Groundwater Remedy Phase 1 Construction, PG&E Topock Compressor Station, Needles, California

Work Variance Request #3 – Proposed changes within the Construction Headquarters (CHQ) fence line

Revised Drawings for Work Variance Request #3

Drawings from Approved Final Design (November 2015)

B SECTION
3/4" = 1'-0"

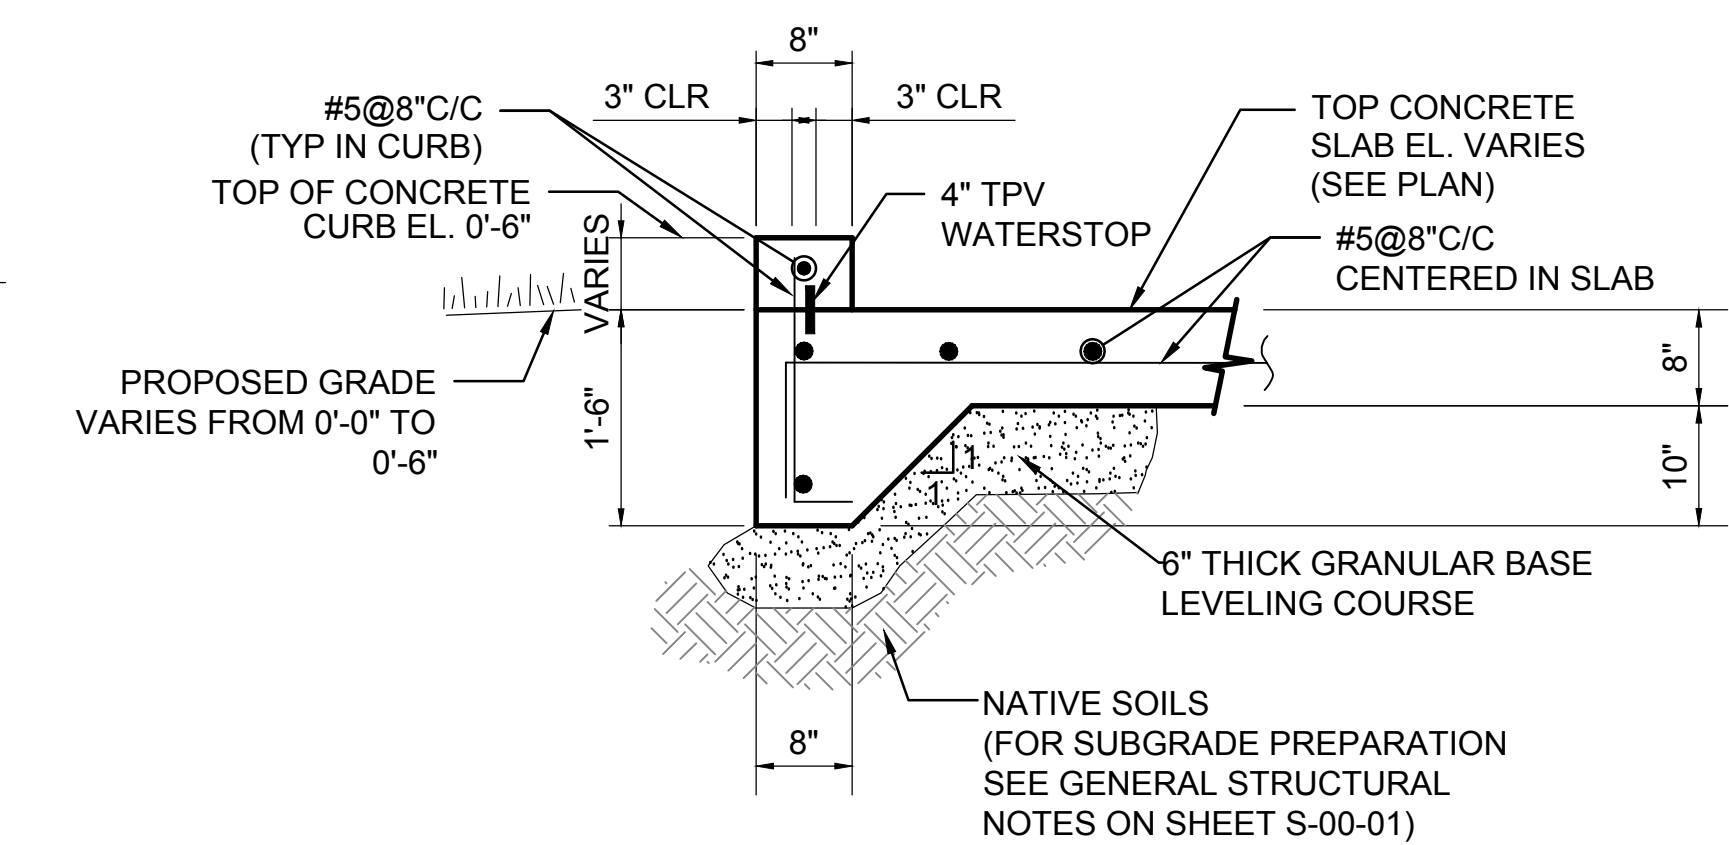
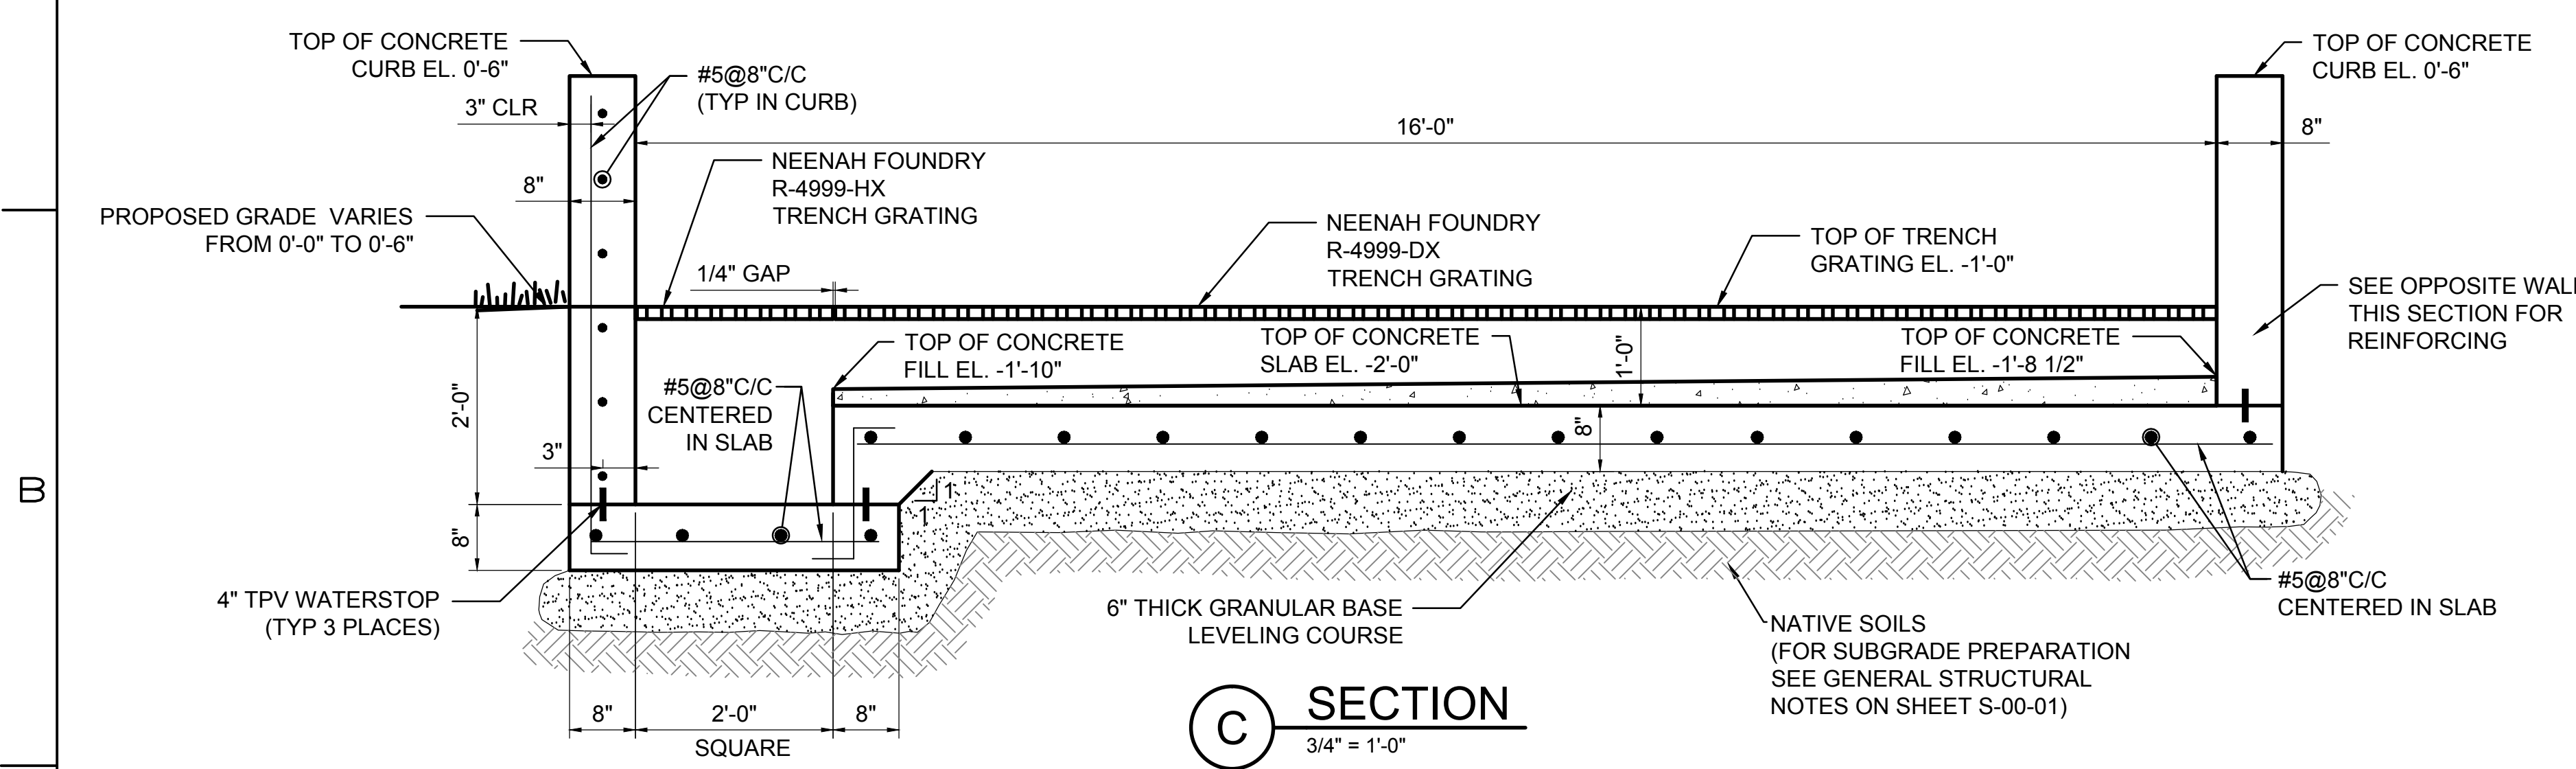
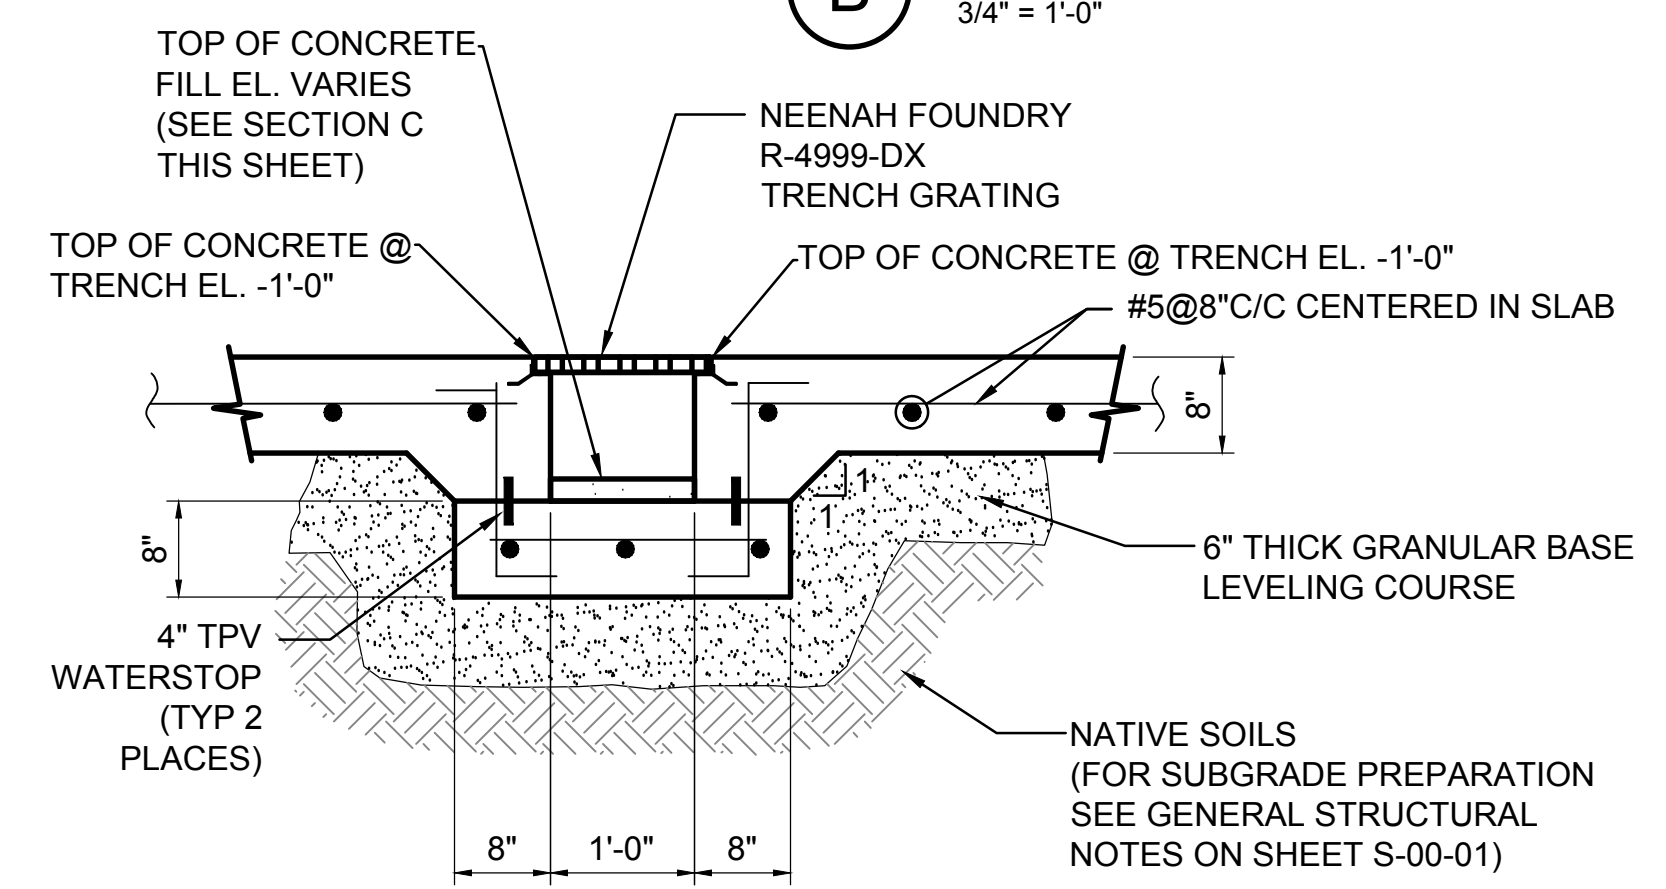
- a) **Relocate the decontamination pad from the western fence to the northern fence (near the western corner).**
Based on recent survey data collected during construction, the difference in ground elevation between northern and southern end of the pad is about 4 feet. Moving the pad to the northern fence would eliminate the difference in ground elevation and reduce the amount of soil disturbance by at least 80 cubic yards.
